# AMENDED PRELIMINARY/FINAL MAJOR SITE PLAN OF THE RUMSON COUNTRY DAY SCHOOL

# MONMOUTH COUNTY DEVELOPMENT REVIEW COMMITTEE

**RE:** RMSP10777 - Rumson Country Day School  
County Route 34 – Ridge Road  
Block 90 – Lots 1.01  
Borough of Rumson

**Re: RCDS – The Rumson Country Day School  
35 Bellevue Avenue; Block 90, Lot 1.01, R-1 Zone  
Amended Preliminary & Final Major Site Plan  
Completeness Review, Engineering Review, and Fee Determination**

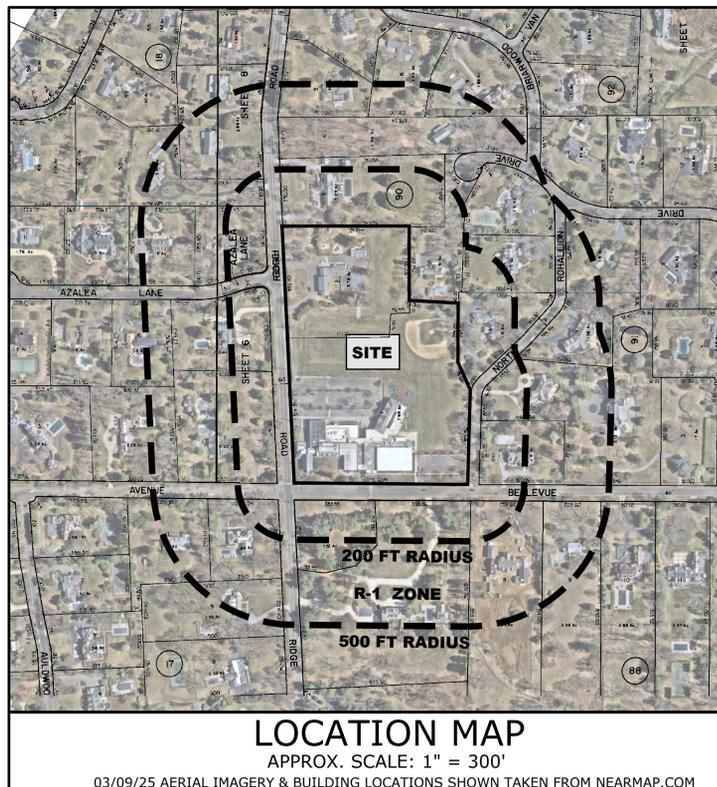
- 1.3 The conditional use standards of Ordinance §22-6.6.d require a minimum lot area of 5 acres plus 1 acre for each 25 students is required. The Zoning Schedule indicates that 23.44 acres is required, whereas the site is 11.69 acres. Therefore, “d” variance relief is required for minimum lot area. The applicant should confirm the existing number and maximum proposed number of students. The plans and schedule should be revised accordingly.

- 1.11 The site plans indicates variance relief is requested for a 2.6 foot side yard setback of an existing shed by the Early Childhood Center, whereas a minimum side yard setback of 15 feet is required per Ordinance §22-5.4.e, Schedule 5-1. Based on review of past approvals, it appears relief was not granted for this shed location. Therefore, a variance may be required. The applicant shall provide testimony to clarify.

## TITLE SHEET

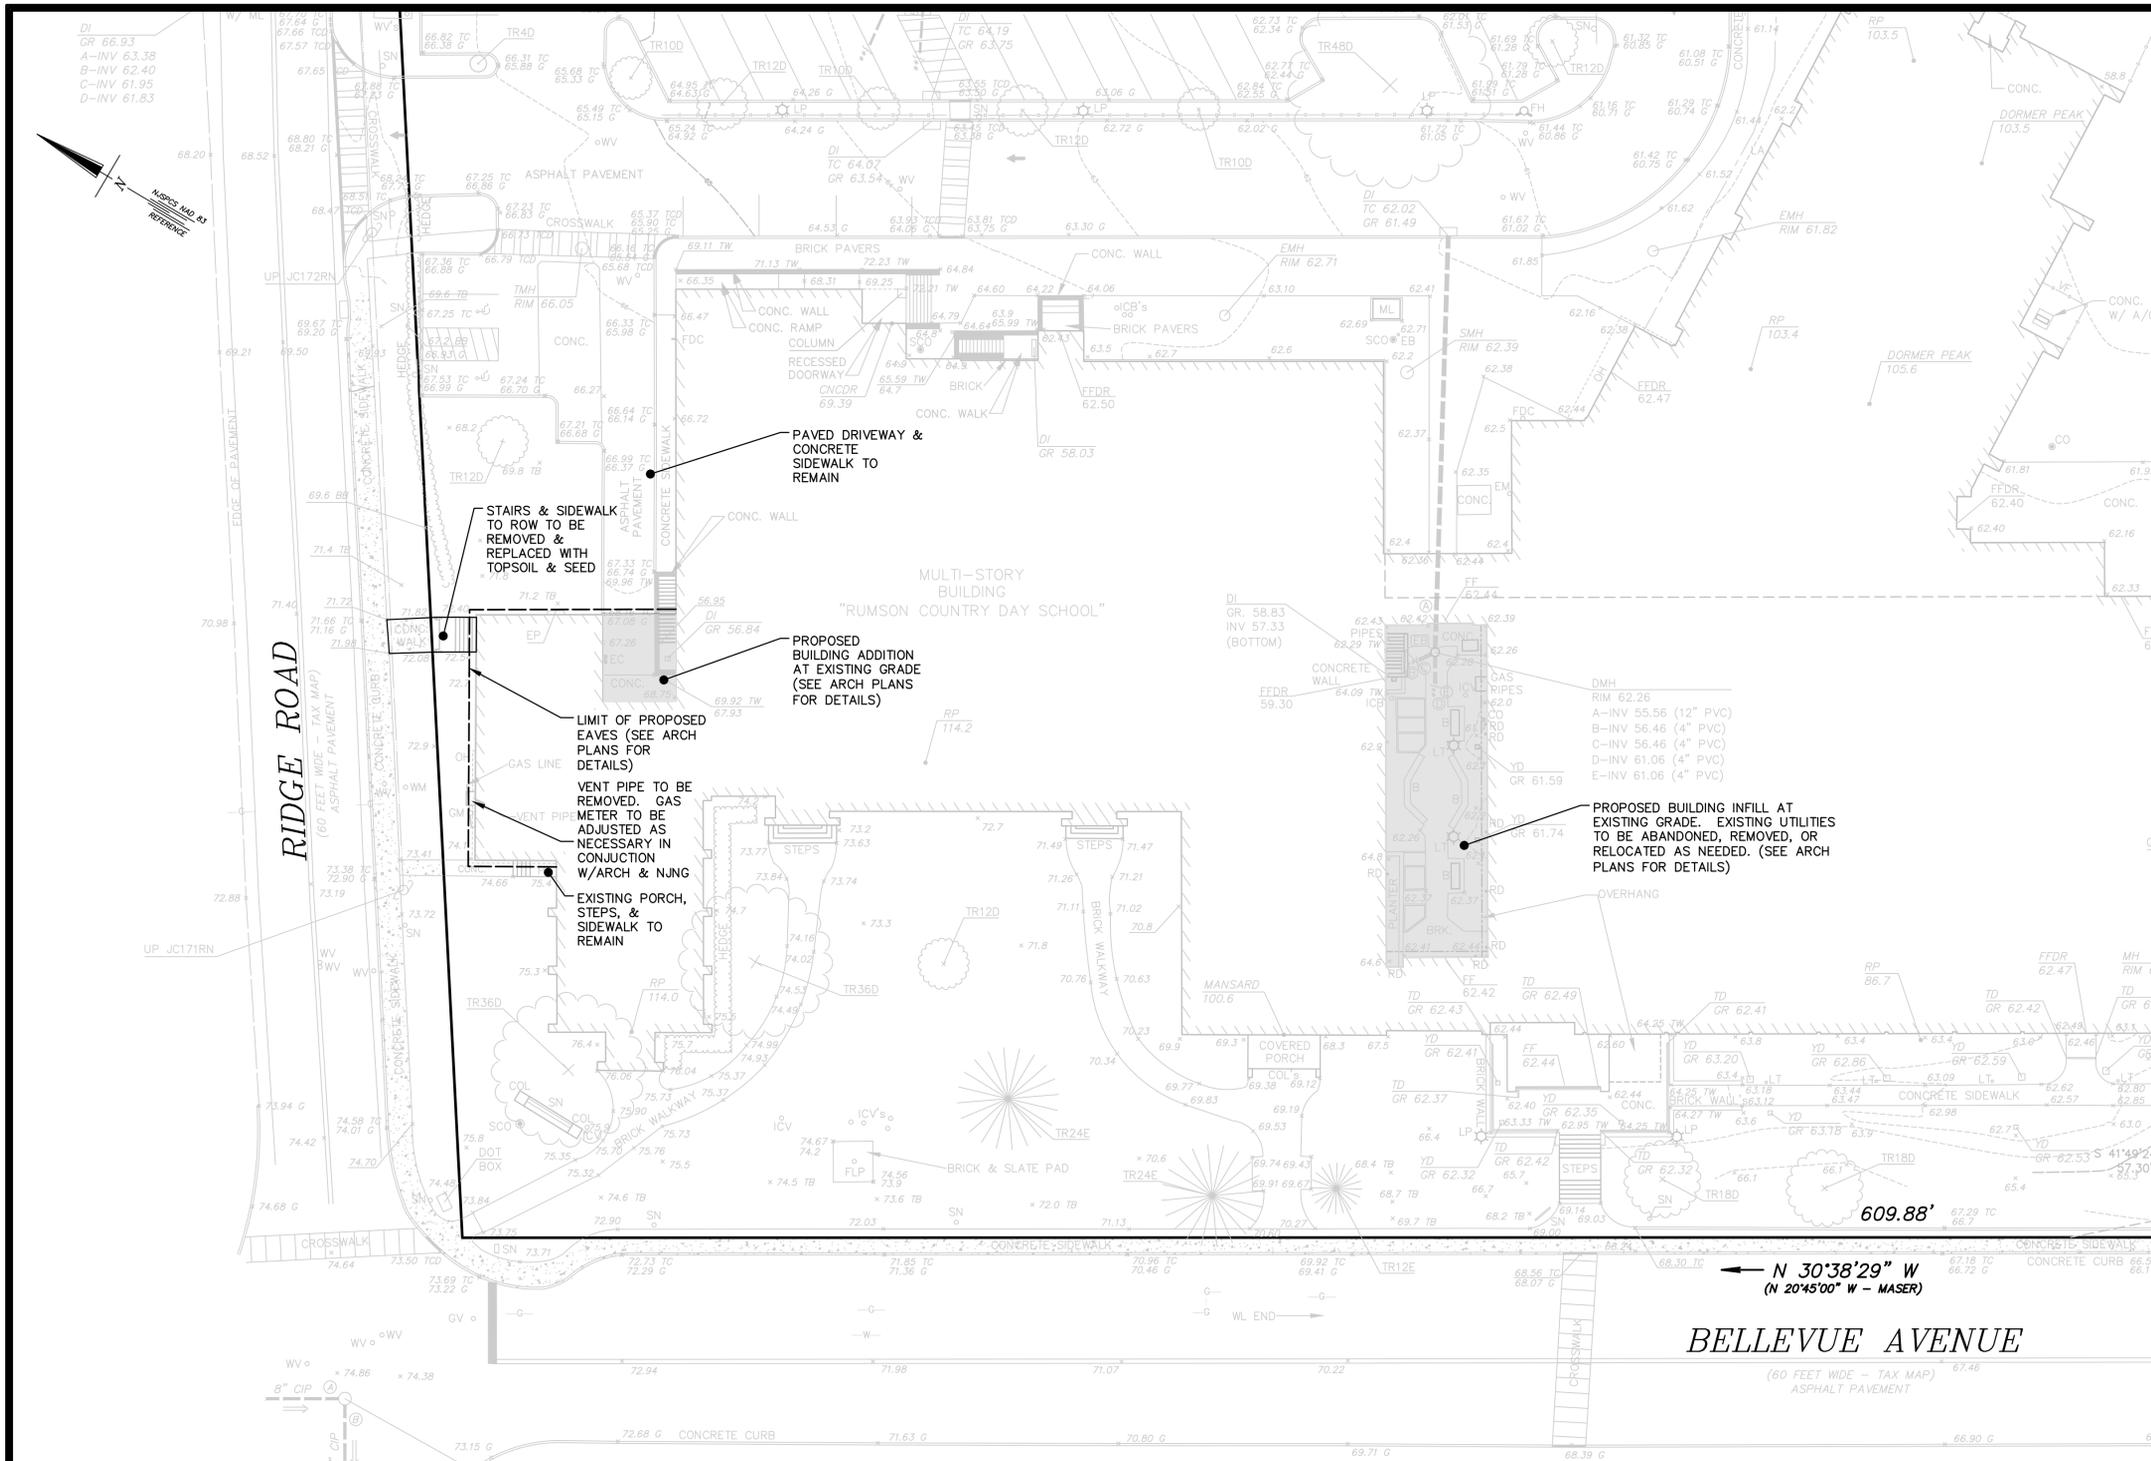
- GC1. On the Site Plan, indicate the right-of-way centerline of C.R. 34, Ridge Road.
- GC2. Provide dimensions from the centerline of C.R. 34, Ridge Road to:
- a. the right-of-way fronting the site;
  - b. the curb or edge of pavement fronting the site;
  - c. the right-of-way & curb or edge of pavement opposite the site.

- GC3. Was the right-of-way established at 30-ft from the centerline of C.R. 34, Ridge Road? If so, indicate on the plans and provide dimension. Indicate the deed book and page. Provide the following information:

- GC4. In addition to the right-of-way dedications noted above, a 25-ft radius corner arc dedication to Monmouth County should be indicated at the corner of C.R. 34, Ridge Road and Bellevue Avenue. Provide the following parcel data:

- GC5. Plans do not indicate proposed work within the Monmouth County right-of-way.
- GC6. Site is tributary to County Structure S-43, Shrewsbury River Tributary at C.R. 520, Rumson Road. A bridge assessment will not be necessary at this time.
